Title of Change:	NCV47722 datasheet update	
Effective date:	26 Jun 2020	
Contact information:	Contact your local ON Semiconductor Sales Office or Juraj.Kremmer@onsemi.com	
Type of notification:	This Product Bulletin is for notification purposes only. ON Semiconductor will proceed with implementation of this change upon publication of this Product Bulletin.	
Change Category:	Datasheet/Product Doc change	
Change Sub-Category(s):	Datasheet/Product Doc change	
Sites Affected:		
ON Semiconductor Sites	External Foundry/Subcon Sites	
None	None

Changes to be implemented in datasheet revision: NCV47722/D, July, 2020 – Rev. 1.

NCV47722

High Side Switch with Adjustable Current Limit and Diagnostic Features

Figure 3. Pin Connections (Top Views)

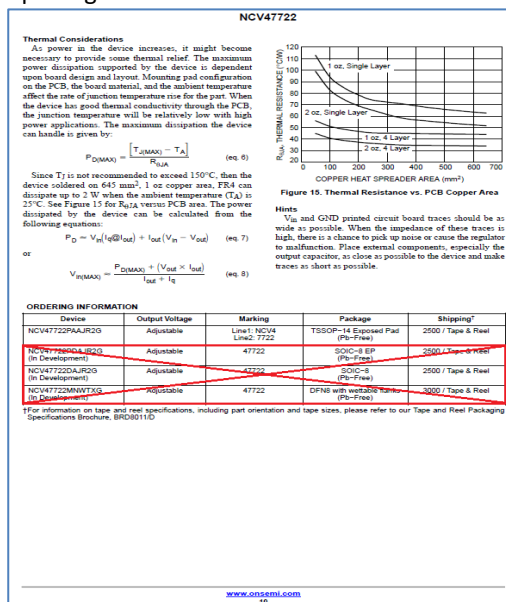
Page 3: Removing SO-8, SO-8EP and DFN8 Pin connections diagrams in Figure 3. And columns belonging to SO-8, SO8EP and DFN8 Pin numbering from Table 1.

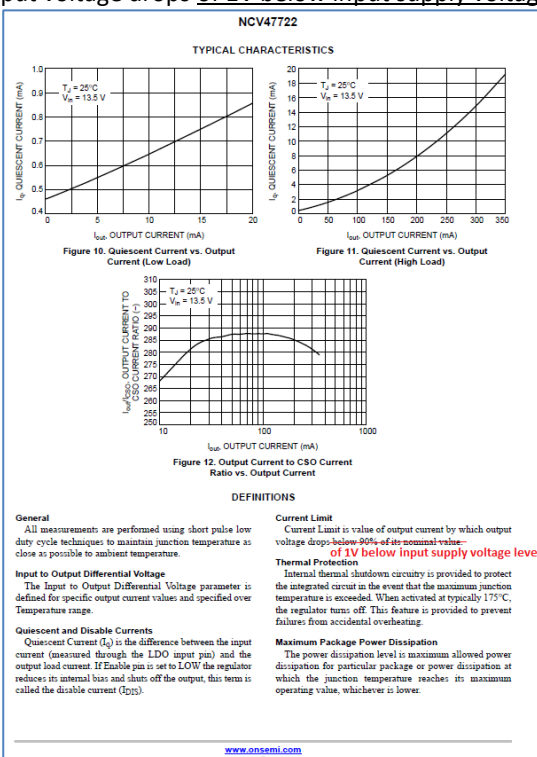
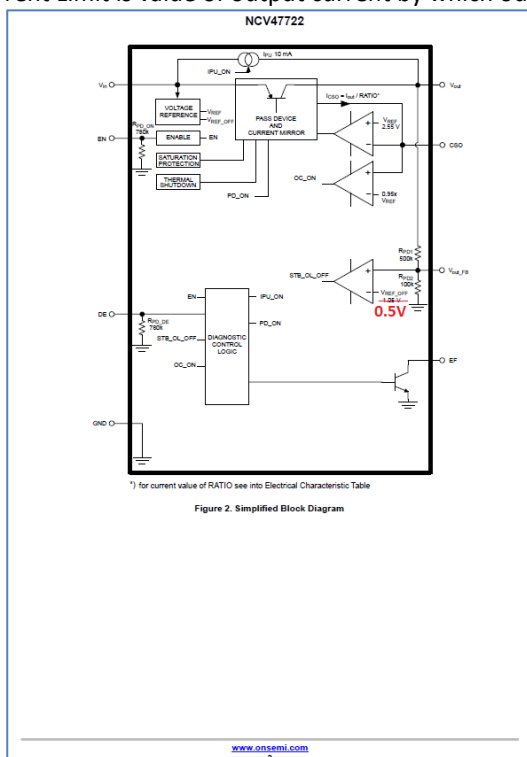
Page 2: Correcting VREF_OFF from 1.05V to 0.5V

Page 7: Correcting the definition of the Current Limit

From: Current Limit is value of output current by which output voltage drops below 90% of its nominal value.

To: Current Limit is value of output current by which output voltage drops of 1V below input supply voltage level.

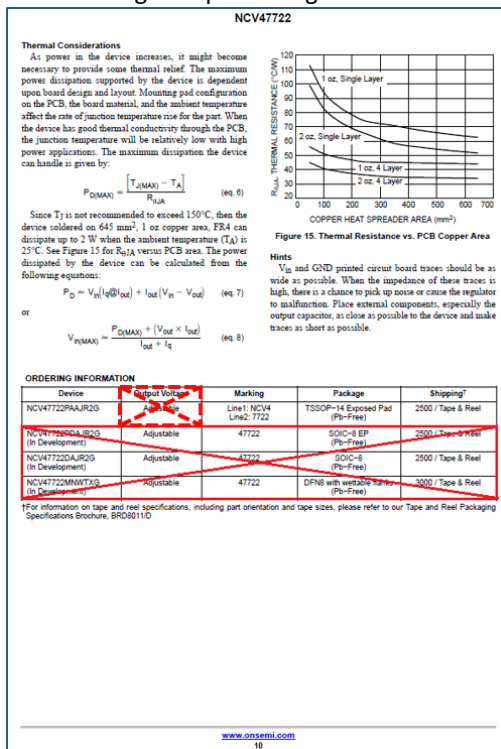
Page 10: Removing SO-8, SO-8EP and DFN8 packages from the ORDERING INFORMATION table.

Page 10: Besides removing package data, also removing "Output Voltage" definition from the ORDERING INFORMATION table.
